A1 Birtley to Coal House

Applicant's Responses to ExA's Second Written Questions - Appendix 2.0E - Structure Options Report 11 - PCF Stage 3 - Allerdene Viaduct

**PCF Stage 3 – Allerdene Viaduct
Structure Option Report No.11**

Safety Engineering & Standards (SES) Record Sheet					
Scheme Name:	Birtley to Coal House Scheme – PCF Stage 3 – Allerdene Viaduct	<u>Comments Sheet Document Control</u>			
		Comment sheet version	Date HA comment sheet	Date Designer's reply sent	Notes
Document Ref	HE551462-WSP-SBR-S3-BR010-X-RP-CB-00001-P01.2	A	25/01/2019	22/03/19 Updated Response 28/03/19	
		B			
AIP version		C			
		D			
AIP Date	19 December 2018	E

LONG SECTION THROUGH CENTRE OF ALLERDENE APPROACH EMBANKMENT
HORIZONTAL SCALE: 1:2,000
VERTICAL SCALE: 1:400

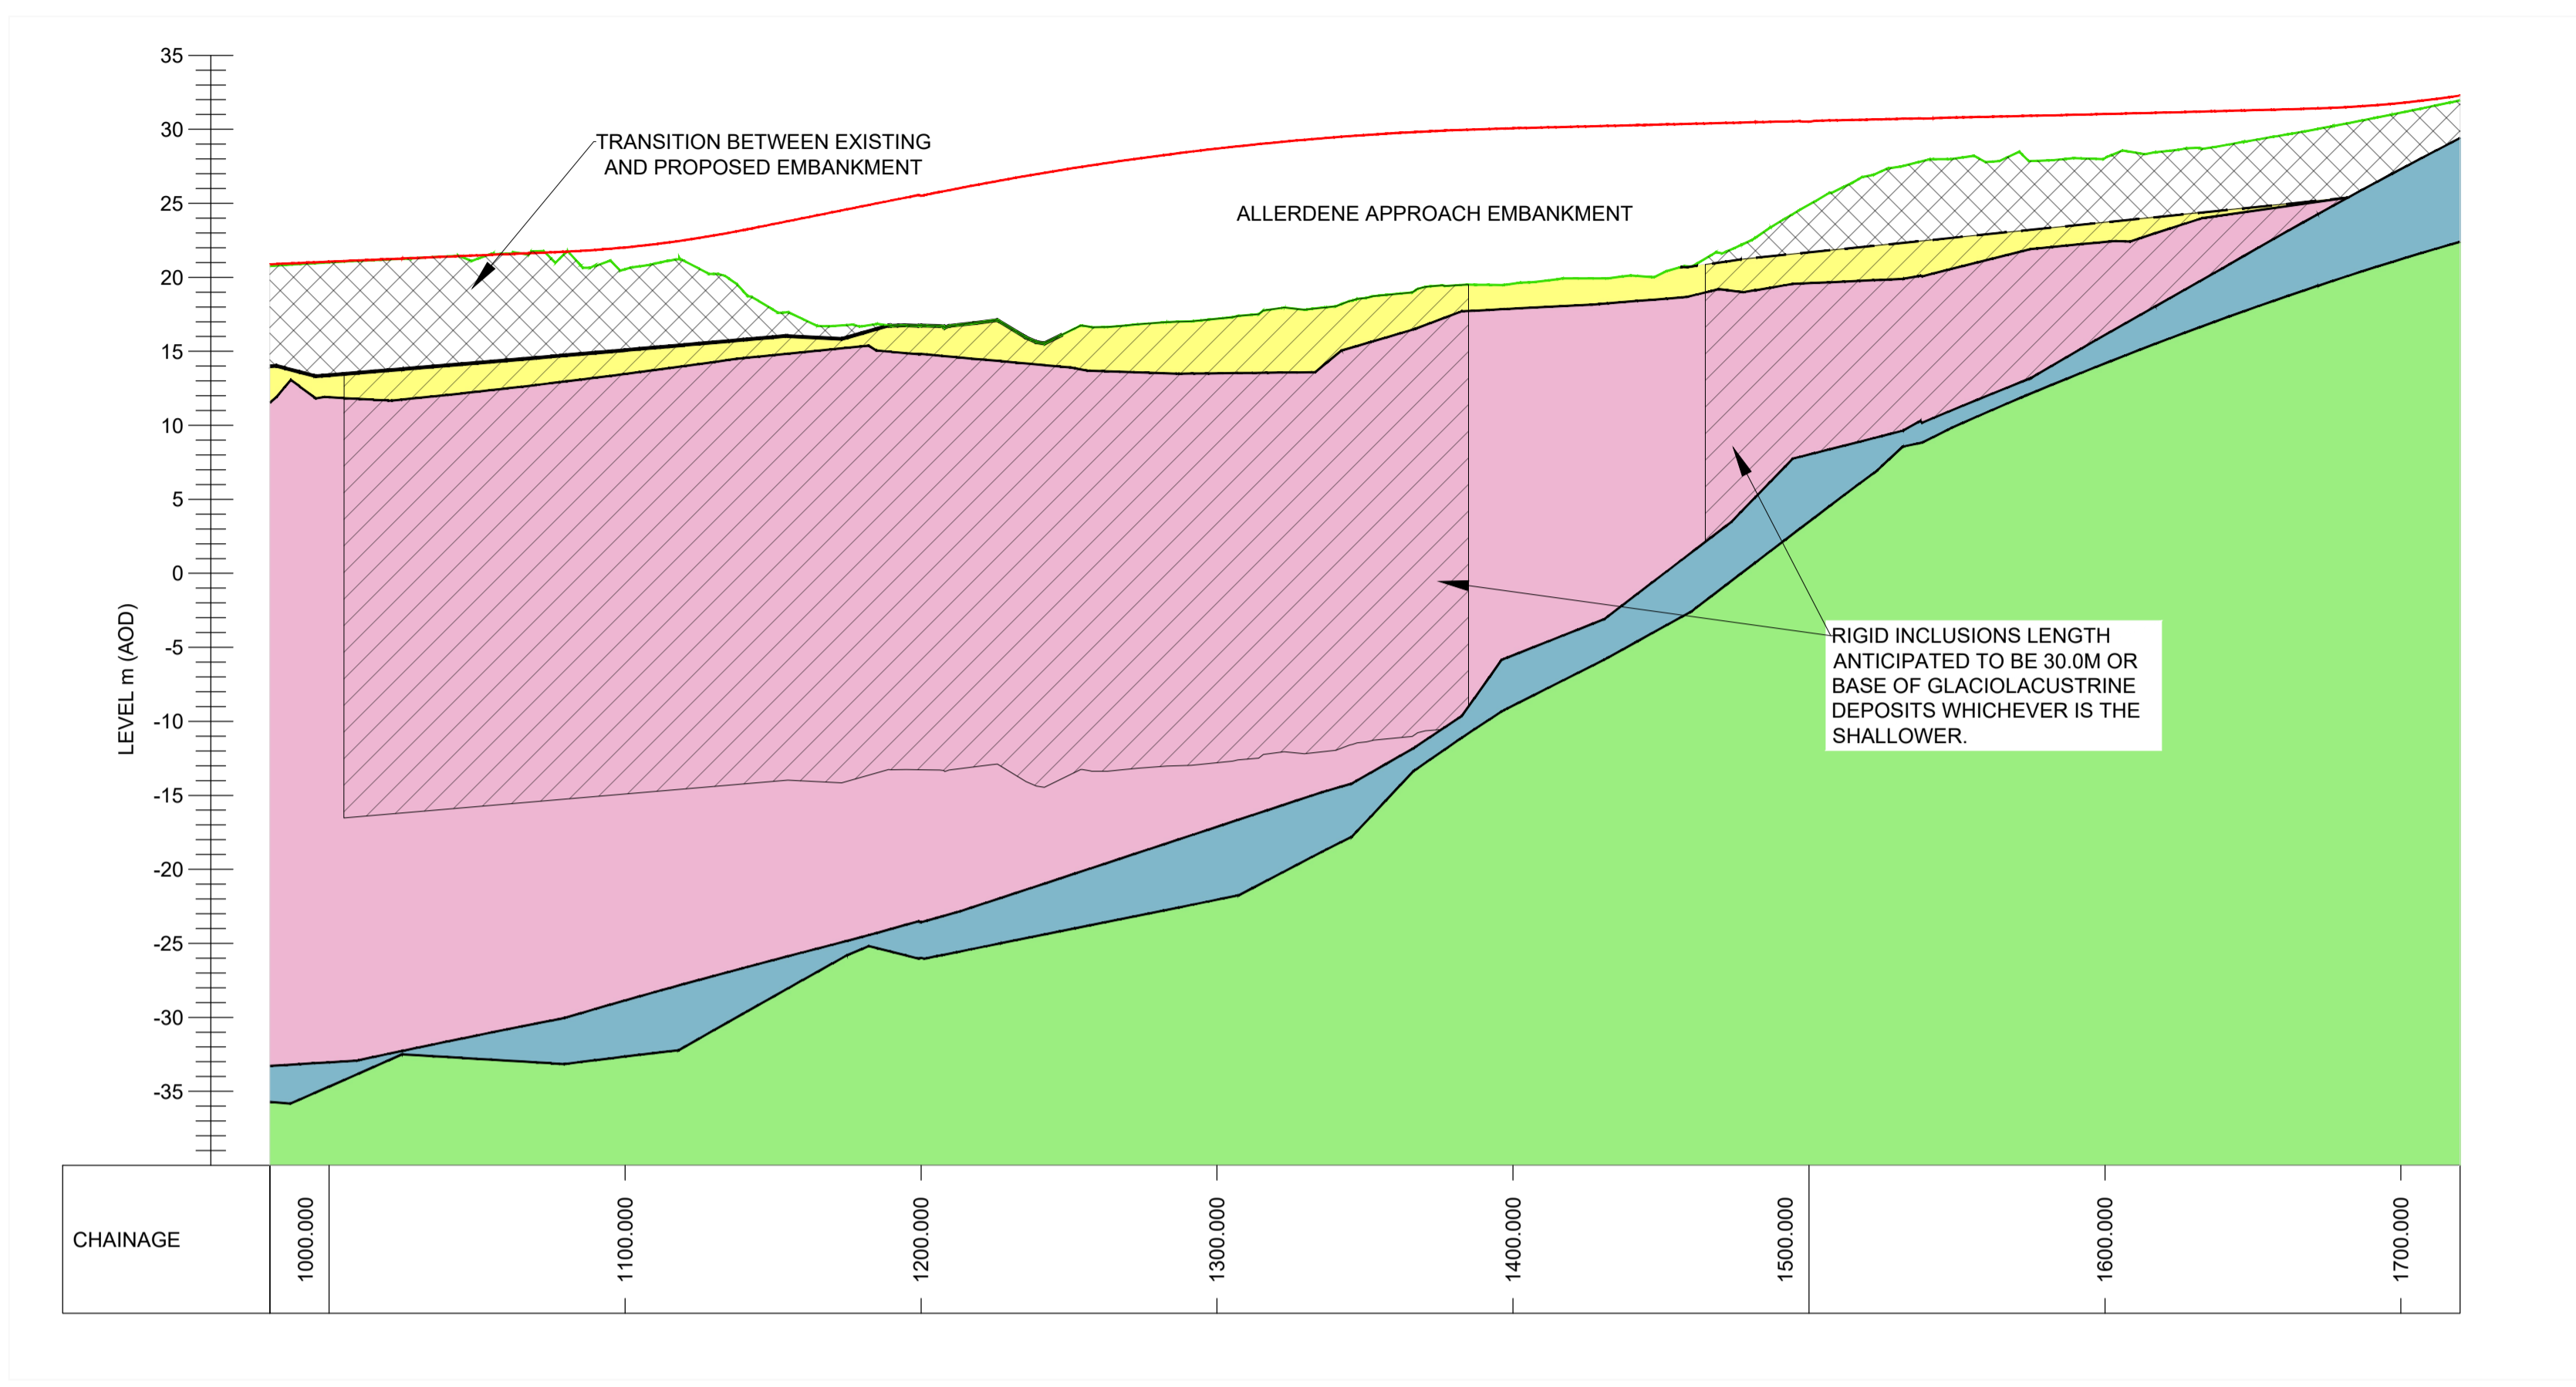
<p>c) Why rigid inclusions are deemed necessary in proximity of and under the existing embankment where over-consolidated ground should be expected (drawing 00107)?</p>	<p>Our view is an extended viaduct length would provide the most robust solution to address ALL the above. Brief details of why smaller span structures have not been considered was highlighted in the conclusion. Some of this information shall be highlighted in section 4.1 of the report.</p> <p>Rigid inclusions are needed within the existing embankment footprint where the proposed embankment is higher than the existing (i.e. increased loading), including on the existing embankment slopes/shoulder.</p> <p>27/03/19 Upon further review response considered adequate to close out comment without amendment to the report. We hope this is ok.</p>	
9	General	<p>Please confirm the cost of Option 2 excludes cost of Allerdene Culvert extension and NG relieving slab protection. Similarly, please confirm Option 1 includes these two structures.</p>	<p>For Option 2 (viaduct), the Allerdene Culvert will be made an open channel and the NGN diversion will be between the piers. This has been accounted for in the cost estimates.</p> <p>Costs within Option 1 include for both the culvert extension and protection slab.</p> <p>27/03/19 Clarification provided in response no change to report required.</p>

39	Drawing 0055 and 107	<p>The way rigid inclusions are shown on these two drawings is confusing. Drawing 107 seems to suggest rigid inclusions are installed under culvert and NG slab yet drawing 0055 shows they are not. Please make consistent.</p> <p>Please review notes on the geotechnical drawings and drawing numbering as there seems to be two separate drawing 107 and notes referring to other drawings that are not included.</p> <p>Why no cut-off shear wall (or similar) is identified on the drawing to help protect ECML? It should be on either side of the track down to rock level.</p>	<p>Noted. Details on drawings 0055 and 107 to be reviewed and updated accordingly.</p> <p>27/03/19 Upon further review drawing ending 0055 to be removed as causing confusion. Minor amendment to dwg 00107 to address comments</p> <p>Refer to response to Comment 6 re: cut off wall.</p>	
40	Drawing 107 – cross section through Ch. 1120	<p>What is the ditch showing? Is there geogrid reinforced granular load transfer mat on the top?</p>	<p>Ditch is shown indicatively, details to be developed at detailed design.</p> <p>27/03/19 Upon further review drawing number to be updated to avoid confusion. Reference to grid also removed as not considered to add any value at this stage.</p>

DRAWING No:	REV:
HE551462-WSP-HGT-BCH-DR-GE-00099	P01

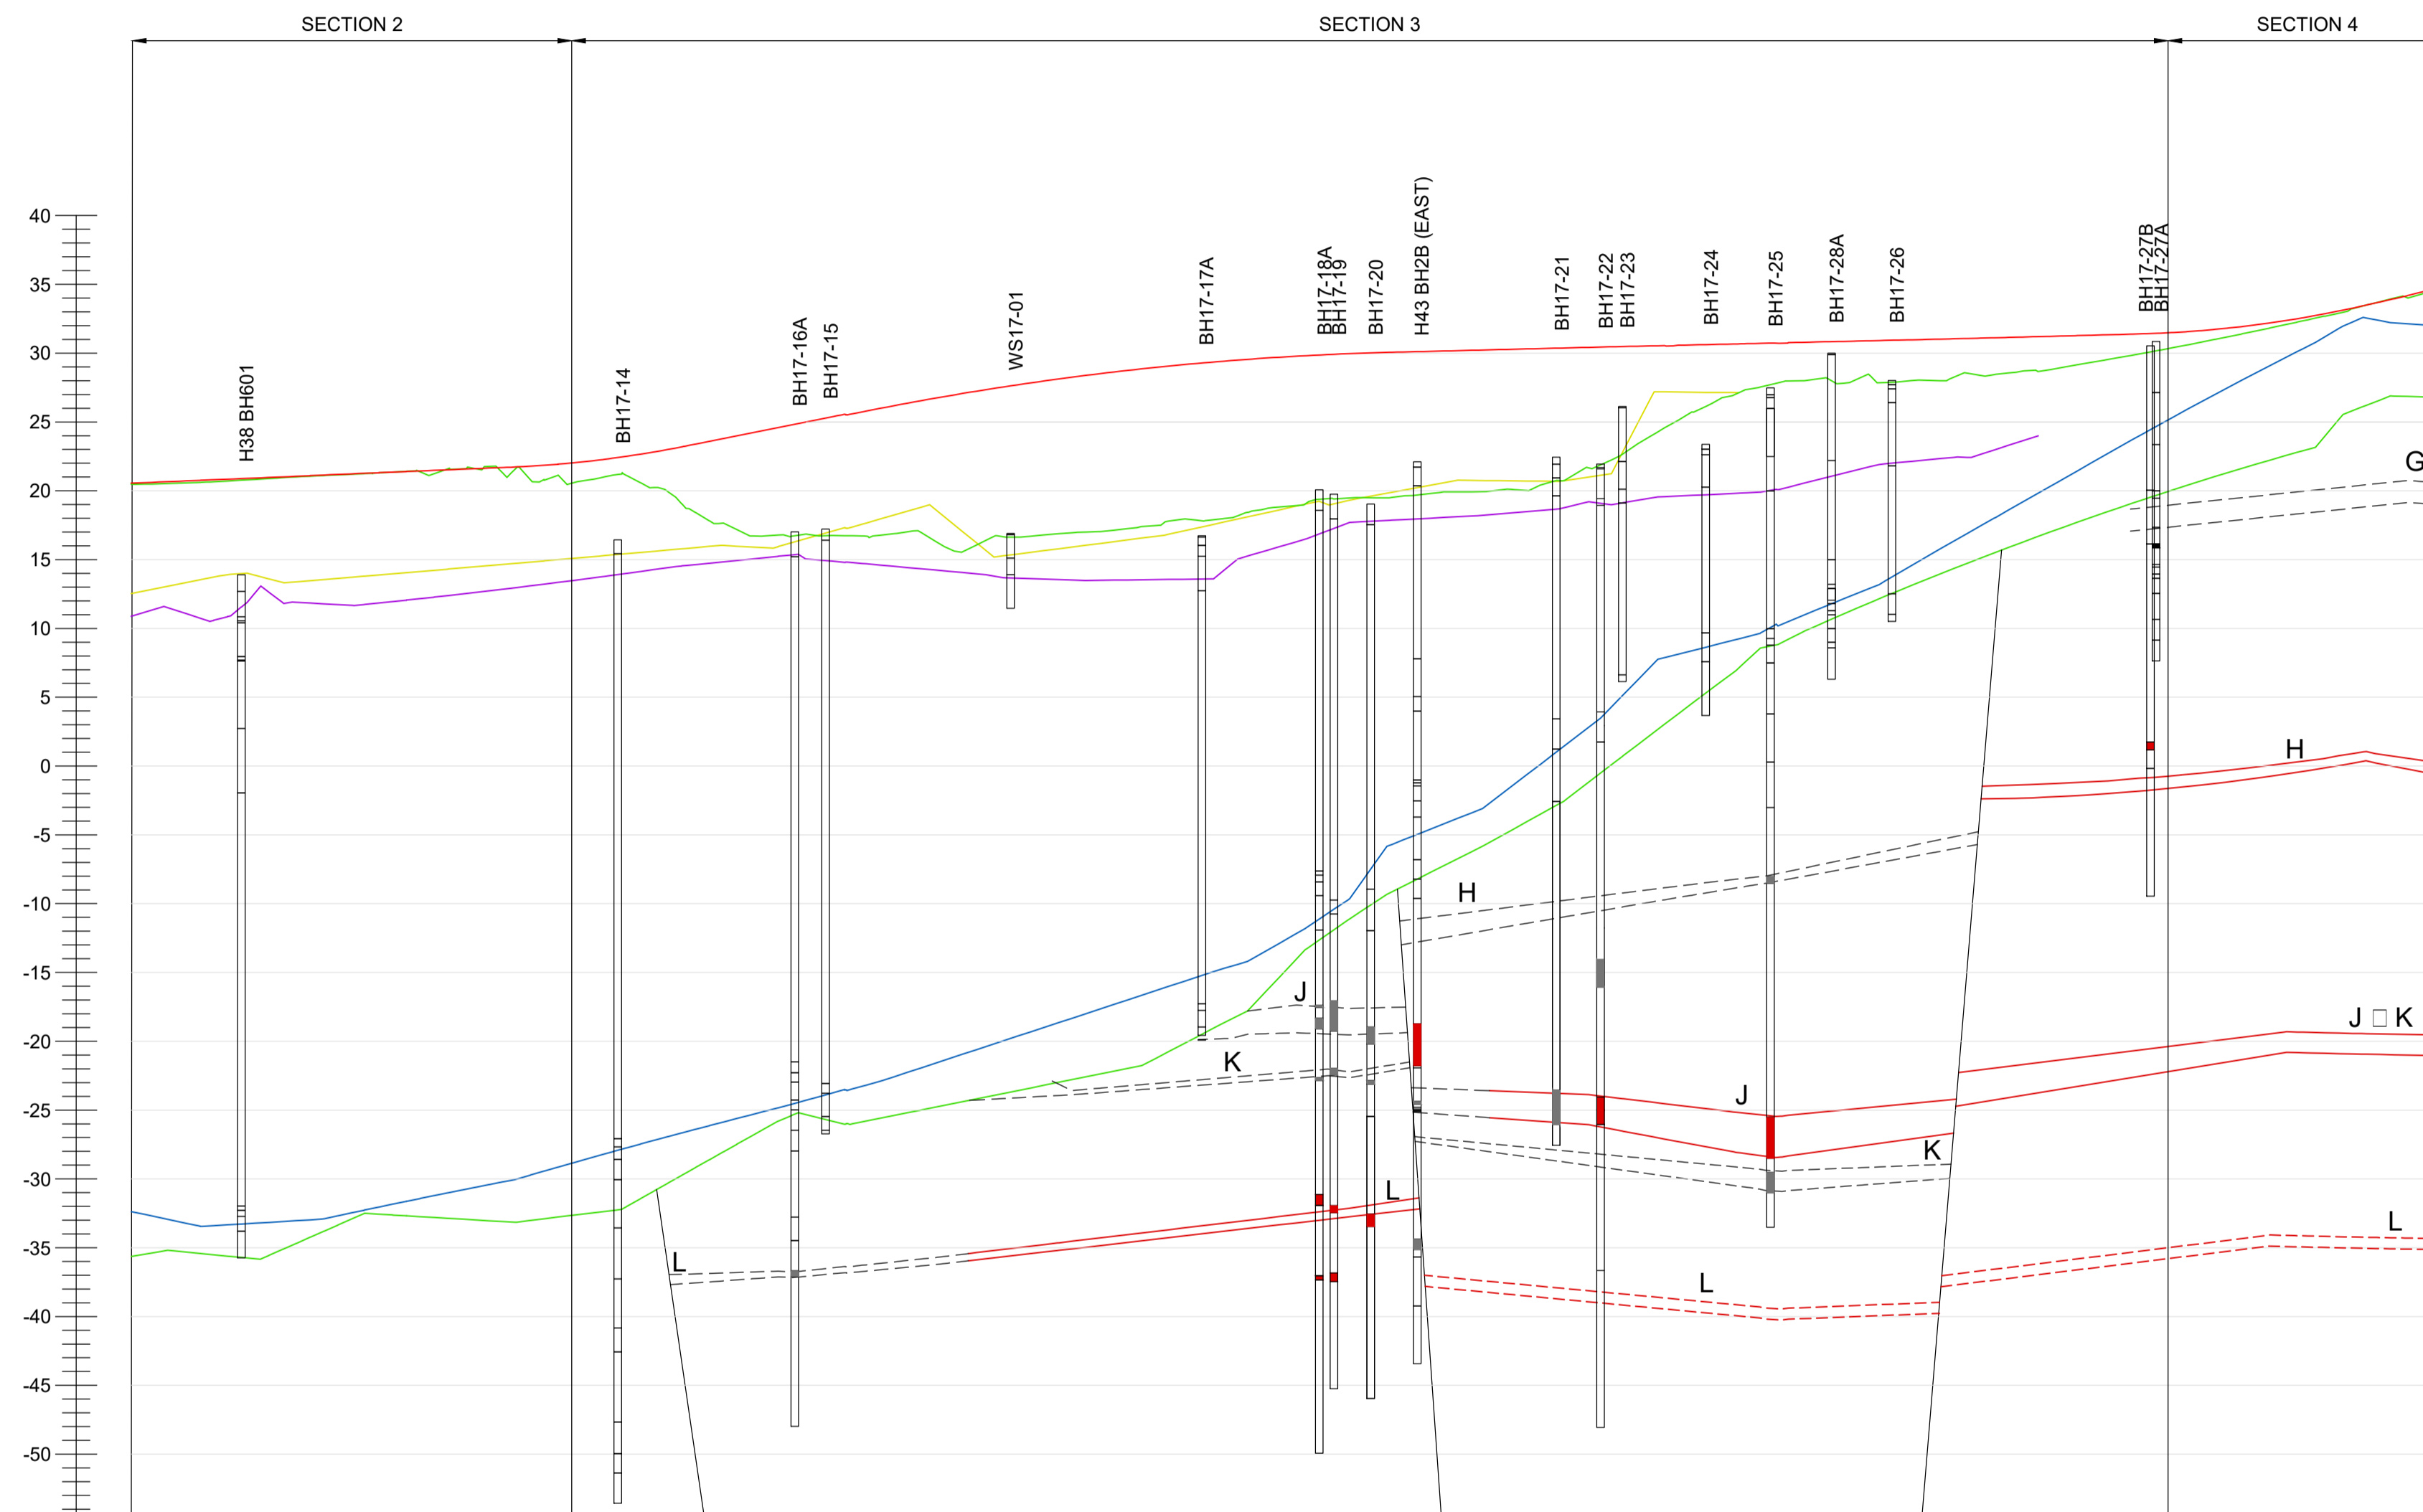
41	Drawing 00099	<p>It would be good to show the boreholes position on plan as well to see how they align with the viaduct option (and show intended pile cap position).</p> <p>Is no gas monitoring proposed for the section with the bridge?</p>	<p>Comments are noted, expect this shall be actioned at detailed design.</p> <p>No gas monitoring was conducted as part of the GI at the express request of HE SES Geotech Advisor at the time.</p> <p>27/03/19 Borehole plan reference included</p>
